**DATE:** 08.28.2018

**FROM:** Mitesh Baxi  
Traffic Engineering

■ **MIKE'Z EXPRESS CARWASH [TRC Plan Review #2]**

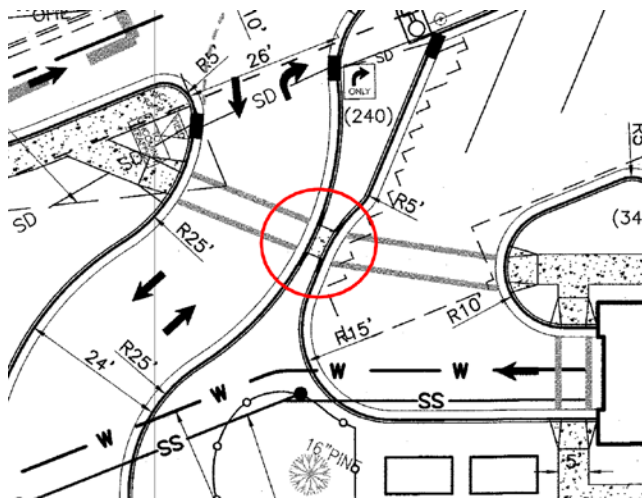
1. The curb ramp at the end of all the sidewalks shall be installed as per City standards. [\[SD 3-07 CofW Tech Stds\]](#). Show the tactile warning mats at all the ramps.
2. The part of a sidewalk between connector driveway and property works as a pedestrian refuge island (image below). So, the treatment shall be done accordingly [MUTCD]. A tactile warning mats shall be installed with a 4' long minimum separation of as per ADA/City standards.
3. Alternatively, provide an island with level cut-throughs if an island will not accommodate curb-ramps with a 4' separation (image below). [\[ADA standards\]](#)
